Our Ref: PL/26/0934
Your Ref:

RE: PROPOSED WORKS TO 3NO. PLANE TREES, 4NO. LIME TREES AND 1NO. SYCAMORE TREE AT 287-291 OXFORD ROAD, READING - SUBJECT TO TREE PRESERVATION ORDER NUMBER 40/13.

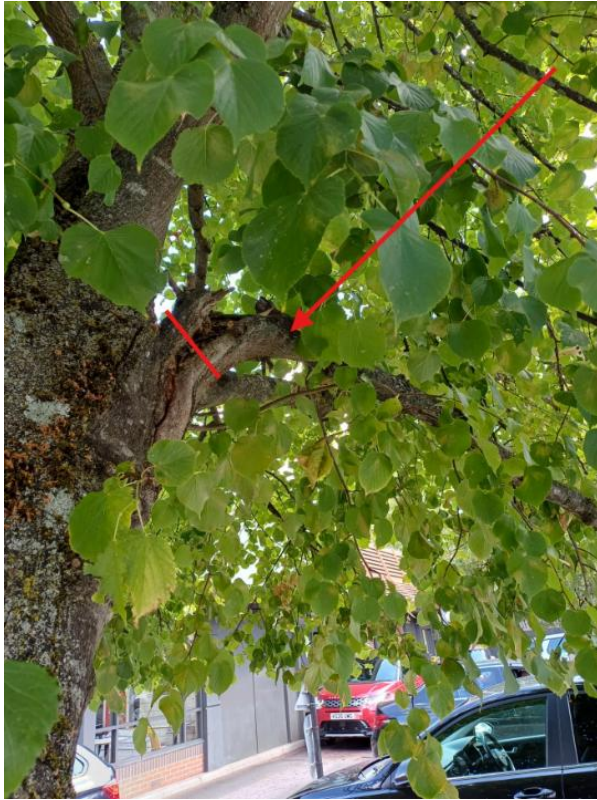
Upon visiting the site, I noted that T6 Lime appeared to be dead, which can be seen in Figure 9. I have therefore, approved the felling of the tree, which will need to be replaced as per Condition 4. The tree appeared newly dead, with this growing season's foliage present, albeit limited and wilted likely due to this year's drought - lesser works are not expected to improve its health. Replacement planting is particularly important on this site, being located in an Air Quality Management Area and directly adjacent to a 'treed corridor' (as defined in our adopted Tree Strategy), where the trees aid in the visual softening of the developed area. As discussed in our email exchanged, it is encouraged that the tree pit is assessed prior to planting its replacement, as it is unclear why T6 has failed, yet T5 & T7 Limes appear to be in good health.

One of the branches of T7 Lime is damaged, hence I have approved the removal of this branch. This is likely due vehicle damage which highlights the importance of regularly inspecting and undertaking works to trees (subject to formal approval), to avoid conflict and thereby damage between the trees and vehicles. I have approved the removal of basal and epicormic growth to T5 & T7 Lime trees, as if left in situ, will continue growing and conflict with the parking spaces hence needs to be removed for clearance purposes, as part of the crown lifting.

In relation to the works to provide clearance of the Lidl sign, only T2 Plane's canopy was encroaching onto the Lidl sign. There are previous pruning points behind the Lidl sign where the secondary branches should be reduced to. It would be difficult to achieve 2m clearance from behind the Lidl sign without removing structural branches and thus the secondary branches should be reduced to established previous pruning points; where there are not previous pruning points, only secondary growth should be removed. It may be that the canopy will overhang the sign but not conflict with it.

I also noted that T3 Plane's canopy is encroaching onto a different adjacent sign, hence pruning to create clearance of this has also been approved.

The reductions to T1 Plane and T4 Sycamore are considered reasonable. Only the lower canopy of the Sycamore is encroaching onto the property (303 Oxford Road) over the single-story extension; hence the reduction of the lower canopy to create clearance has been approved. T1 Plane is overhanging the frontage, but it was difficult to assess what 2m of clearance would be considered as and could reduce all the tree's canopy back to the boundary line of the retail park, depending on how it was interpreted. The tree is slightly conflicting with the property, so reducing to provide clearance of the property is reasonable. I appreciate that the tree does overhang the frontage, albeit a clearer specification was required for the above reason. The reduction approved is more specific and will have a lesser impact to the tree's health.

- T1 Plane: crown lift secondary branches, through 360°, to approximately 2.75m above ground level over the public pavement and 5.5m over the highway, but 1m above the height of the substation; reduce secondary branches growing towards the adjacent property to create approximately 1-1.5m clearance (see Figure 1); reduce secondary branches growing towards the adjacent property's driveway by 1-1.5m from the furthest extremity (see Figure 2), leaving suitable growth points

- T2 Plane: crown lift secondary branches, through 360°, to approximately 2.75m above ground level over the public pavement and 5.5m over the highway, leaving suitable growth points; reduce/remove secondary branches conflicting with the Lidl sign, back to previous pruning points (see Figure 3), and reduce any overhanging, secondary branches provide approximately 1m horizontal clearance from the sign and approximately 1m lateral clearance above the sign

- T3 Plane: crown lift secondary branches, through 360°, to approximately 2.75m above ground level over the public pavement and 5.5m over the highway; reduce secondary branches growing towards the sign (see Figure 4) to provide approximately 1m vertical from the sign and 1m lateral clearance from the signpost; reduce secondary only branches overhanging McDonald's drive-thru back to the outer extremity of the parking edge (Figure 5), leaving suitable growth points

- T4 Sycamore: crown lift secondary branches, through 360°, to approximately 2.75m above ground level; reduce the lower secondary branches growing towards the adjacent property to create approximately 1.5-2m horizontal and vertical clearance (see Figure 6), leaving suitable growth points.

- T5 Lime: remove basal and epicormic growth (see Figure 7), through 360°, to the height of 2.75m above ground level; crown lift secondary branches, through 360°, to approximately 2.75m above ground level, leaving suitable growth points; remove one identified branch back to source (see Figure 8)

- T6 Lime: fell to ground level
- T7 Lime: remove basal and epicormic growth, through 360°, to the height of 2.75m above ground level; crown lift secondary branches, through 360°, to approximately 2.75m above ground level, leaving suitable growth points
